UNITED STATES PATENT AND TRADEMARK OFFICE

APPLICATION NO.	FILING DATE	FIRST NAMED INVENTOR	ATTORNEY DOCKET NO.	CONFIRMATION NO.
10/762,772	01/22/2004	Stephen W. Briggs III	BBMED.004A	3108

Office Action Summary

DETAILED ACTION

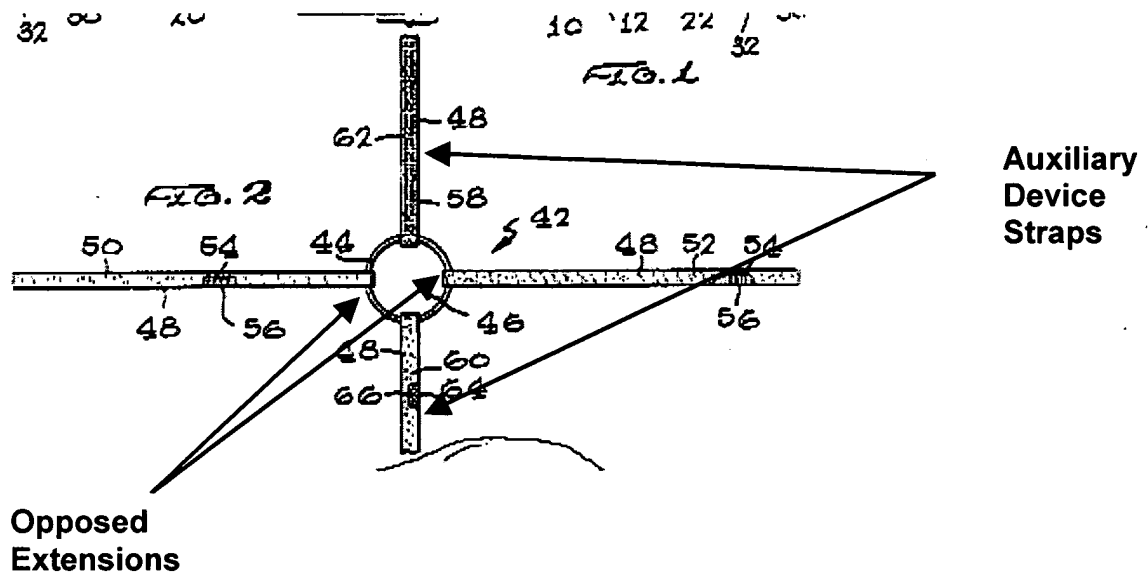
Briggs in a securing apparatus for tracheostomy tubes discloses:

- a ring (44) having a pair of opposed extensions defining strap holds (Col. 3, lines 36-48), and further having a pair of secondary strap holds (see illustration of Fig. 2 below); a void (46) within the ring (44) configured to allow passage of a tracheostomy tube (38) through the ring (44);
- a pair of auxiliary device straps (see illustration of Fig. 2 below) affixed to each of the secondary strap holds, the auxiliary straps configured so that when the tracheostomy tube extends through the ring void (46), the auxiliary straps extend around an auxiliary device (40) that is fit onto the tracheostomy tube (Fig. 5) so as to maintain a maximum spatial relationship between the auxiliary device and the ring (44).
